Access Compliance Report

Public Rights-of-Way

(Curb Ramps)

Intersection ID: 53147	Main Street: ACHIEVEMENT_LN	Cross Street: NEW_RENAISSANCE_WY	Location: W
ADA ID: F21518C17587	Ramp Type: Directional1	Initial Pass/Fail: Fail	Overall Compliance: No
		Severity Score: 1.25

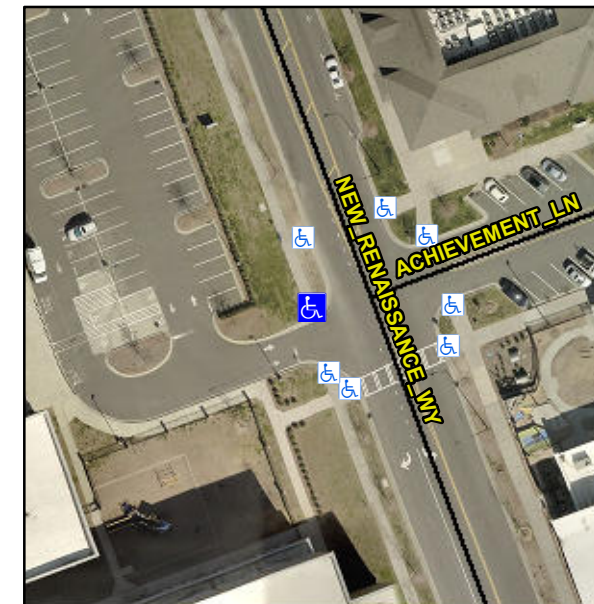
R304.5.3

Compliance	Description	Data	Compliance	Description	Data
N/A	Ramp Length (in)	60.0	N/A	Grade Break?	N/A
Yes	Ramp Width (in)	70.0	N/A	Grade Break Slope (%)	0.0
Yes	Ramp Slope (%)	8.1	N/A	Grade Break XSlope (%)	0.0
No	Ramp XSlope (%)	3.0			
N/A	Flare Type LT	N/A	N/A	Flare Type RT	N/A
N/A	Flare Slope LT (%)	N/A	N/A	Flare Slope RT (%)	0.0
N/A	Flare Traversable LT?	N/A	N/A	Flare Traversable RT?	N/A
N/A	Landing Length (in)	0.0	N/A	DWS Provided?	N/A
N/A	Landing Width (in)	0.0	N/A	DWS Contrast?	N/A
N/A	Landing Slope (%)	0.0	N/A	DWS Length (in)	N/A
N/A	Landing X Slope (%)	0.0	N/A	DWS Full Width?	N/A
N/A	Landing Curb? (Y/N)	N/A	N/A	DWS Offset LT (in)	N/A
N/A	Shared Landing?	N/A	N/A	DWS Offset RT (in)	N/A
N/A	Gutter Ponding?	0.0	N/A	Gutter Slope (%)	N/A
N/A	Gutter Lip Ht (in)	0.0	N/A	Gutter X Slope (%)	N/A
N/A	Painted X Walk1?	No		Road Slope (%)	0.8
	X Walk 1 Direction	To SE		Road X Slope (%)	0.8
	X Walk 1 Width (in)	N/A		Clear Space?	N/A

Remove & Replace Entire Ramp.
